Town of Franklin

Conservation Commission

To: Franklin Conservation Commission
From: Breeka Li Goodlander, CWS, PWS, CERPIT
Re: Conservation Agent Report
Date: March 7, 2024

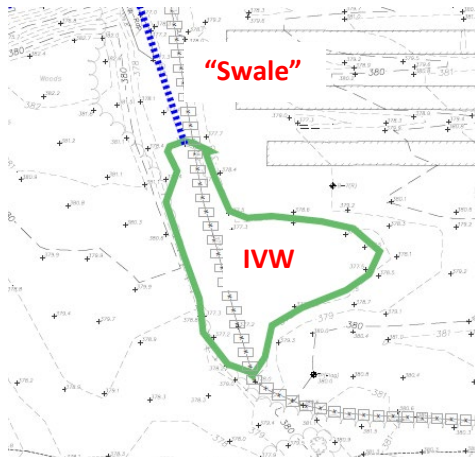
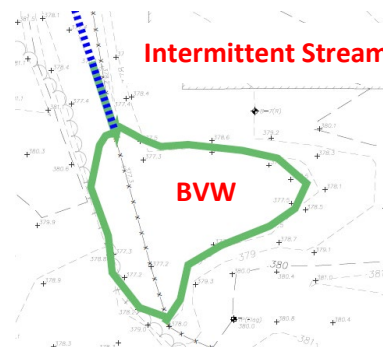
Agent defer to the Commission on determination of jurisdictional status. The Commission may classify the wetland as IVW, inclusive of a portion of the stormwater “swale” until the predominance of a riprap bottom; or the Commission may classify the wetland as BVW, with the majority of the “swale” considered as intermittent stream. The “swale” is denoted on previously approved plans as a drainage ditch and does consist of a predominant riprap bottom with questionable soils. The “swale” does have hydrology and wetland vegetation. The Commission is tasked with determining if the area is a smaller BVW with an intermittent stream, or a larger IVW (inclusive of a portion of the “swale” without riprap) with connection to a pre-existing drainage ditch. Regardless of classification, it is recommended the Commission consider a portion of this area as Vernal Pool and condition a survey during vernal pool season as part of the ORAD. Picture examples are shown below. These areas are approximated to show shape of proposed resources, but not true to onsite conditions or delineated areas. The onsite visit did review and confirm the boundaries of the northerly IVW and IVWs between the solar panels.

Example: IVW with “swale”

Example BVW with Intermittent Stream
